**DOCKET ITEM #10**  
**Master Plan Amendment #2021-00001**  
**Rezoning #2021-00002**  
**Development Special Use Permit #2021-10013 (Stacked Townhouses)**  
**Development Special Use Permit #2021-10014 (Multifamily Buildings)**  
**Development Site Plan #2021-00004 (Public Streets)**  
**Special Use Permit #2021-00025 (TMP – Stacked Townhouses)**  
**Special Use Permit #2021-00108 (TMP – Multifamily Buildings)**  
**Special Use Permit #2021-00059 (Coordinated Sign Plan)**  
**Landmark Overlook – 5901, 5951 & 5999 Stevenson Avenue and 2 South Whiting Street**

<b>Staff Recommendation: APPROVAL WITH CONDITIONS</b>
<b>Staff Reviewers:</b> Robert M. Kerns, AICP, Division Chief <a href="mailto:robert.kerns@alexandriava.gov">robert.kerns@alexandriava.gov</a> Maya Contreras, Principal Planner <a href="mailto:maya.contreras@alexandriava.gov">maya.contreras@alexandriava.gov</a> Nathan Randall, Urban Planner <a href="mailto:nathan.randall@alexandriava.gov">nathan.randall@alexandriava.gov</a>

Master Plan Amendment #2021-00001  
Rezoning #2021-00002  
Development Special Use Permit #2021-10013 and #2021-10014  
Development Site Plan #2021-00004  
Transportation Management Plan Special Use P

Figure 4-11 Conceptual Land Use Map for Redevelopment Area, as amended

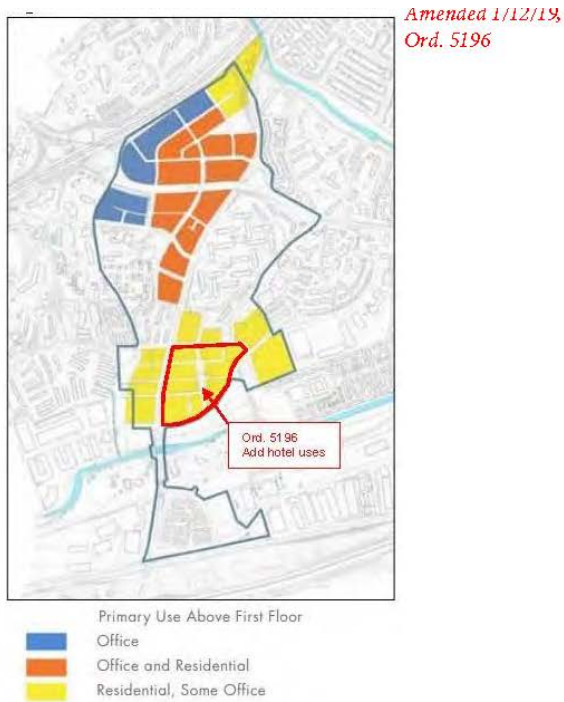
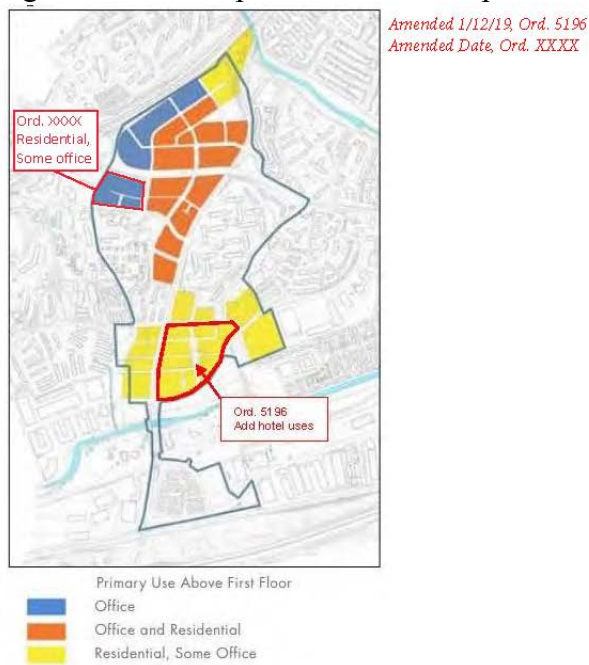
- Amend Figure 4-11 Conceptual Land Use Map for Redevelopment Area to reflect a change in primary use above first floor from ‘Office’ to ‘Residential, Some Office’;

Figure 6-11 (page 108) as amended

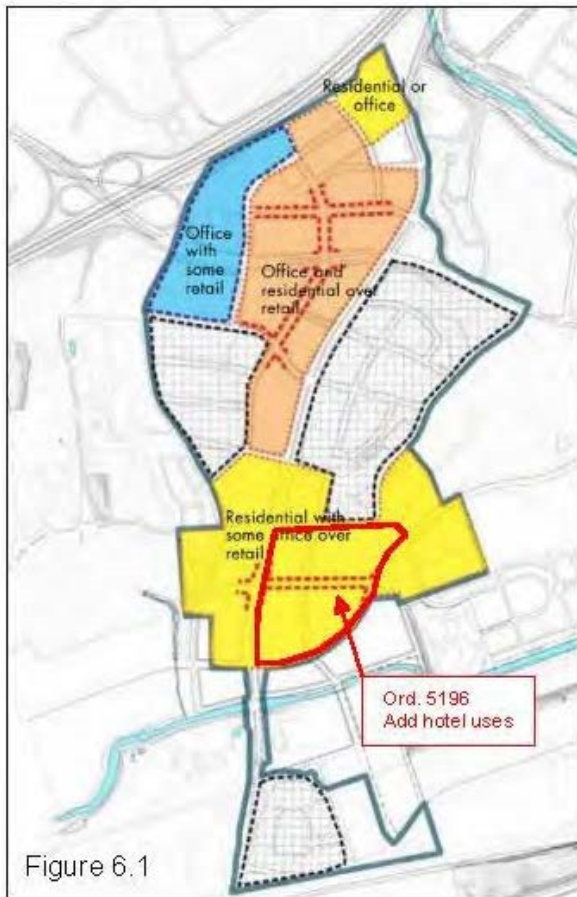
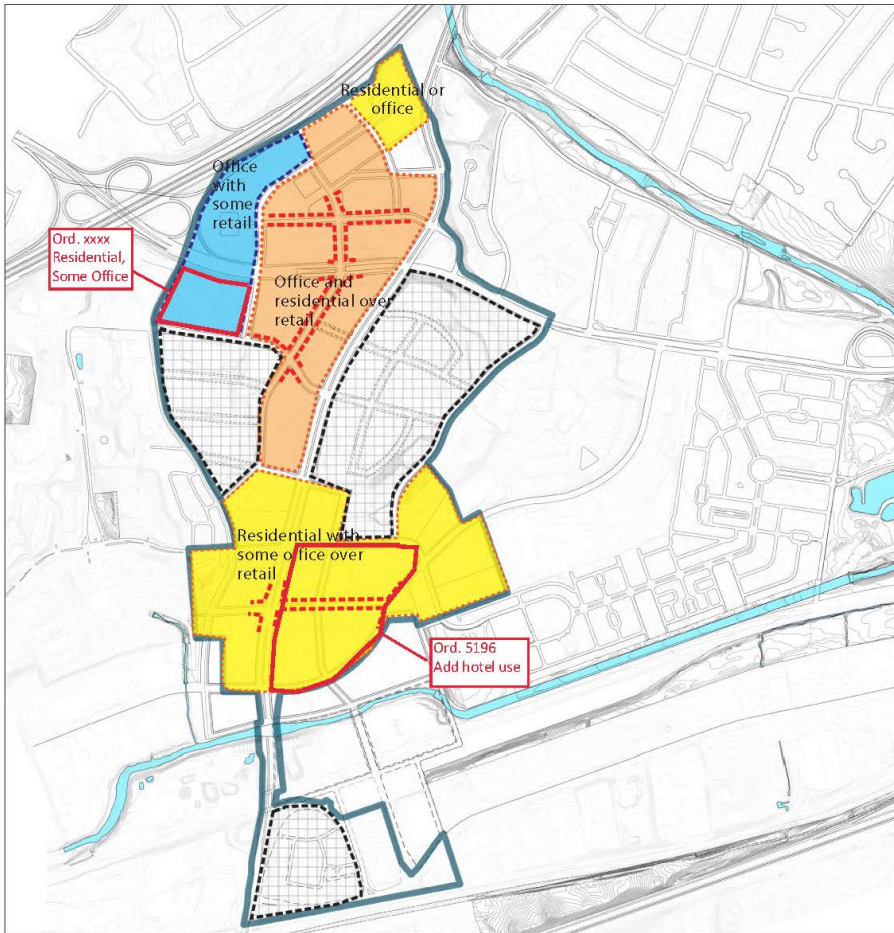
- Amend Figure 6-11 to reflect a change in use from ‘Office with Some Retail’ to ‘Residential, Some Office’; and
  - Amend Figure 7-13 Generalized Land Use to reflect a change in use from ‘Office’ to ‘Residential, Some Office’.
